REPORT TO CITY OF VISALIA PLANNING COMMISSION

HEARING DATE: April 13, 2015

SUBJECT: Exception No. 2015-02: A request by Sandra De Azevedo property owner, to allow

a six-foot high chain link fence in the front setback along NW 2nd and West Streets, in the Single Family Residential (R-1-6) zone. The site is located at 405

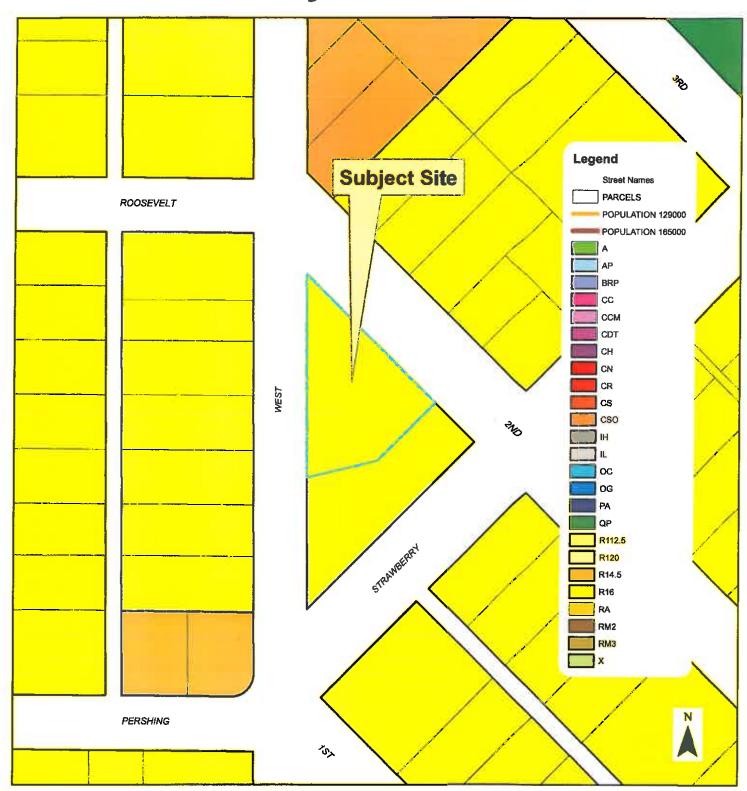
- 1. New fence shall be installed at or behind property line.
- 2. Comply with City standards.

Primary Access Driveway & Drive Aisle

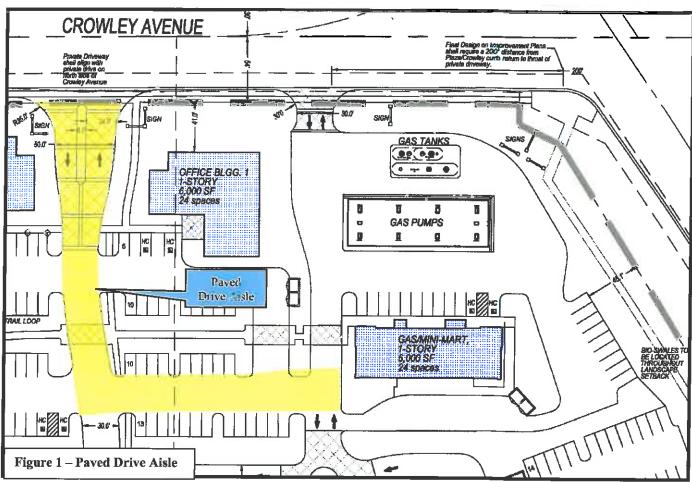
Staff is requesting the Planning Commission approve Condition No. 4 requiring the construction of the primary drive aisle thereby providing a secondary point of access to the ARCO gas station site. The requirement to provide two points of access onto the site alleviates any potential unsafe left turn movements from Crowley Avenue onto the ARCO gas station site if the only ingress/egress, as depicted on Exhibit "A" for the ARCO gas station site, were constructed. Figure 1 provides an illustration of this requirement.

During the Site Plan Review meeting, staff noted the potential for traffic conflicts to occur in the Crowley right-of-way if only one point of ingress/egress were constructed with the ARCO gas station. The primary issue is vehicles queuing in the left turn pocket waiting to go north on Plaza Drive impeding westbound vehicles from entering the ARCO gas station site. Other traffic concerns include left turn movements for tractor trailers and/or large delivery vehicles waiting to enter the gas station site if only one point of ingress/egress is constructed. These concerns/issues resulted in staff informing the applicants that a secondary point of ingress/egress would be included as part of the conditions of project approval for the CUP.

- 4. That the primary drive aisle be constructed with the Phase 1 and/or the ARCO gas station development, providing a secondary point for vehicular ingress/egress onto the entire 25-acre master planned site and to facilitate a secondary vehicular access point to the ARCO gas station as depicted in Figure 1 of the staff report.
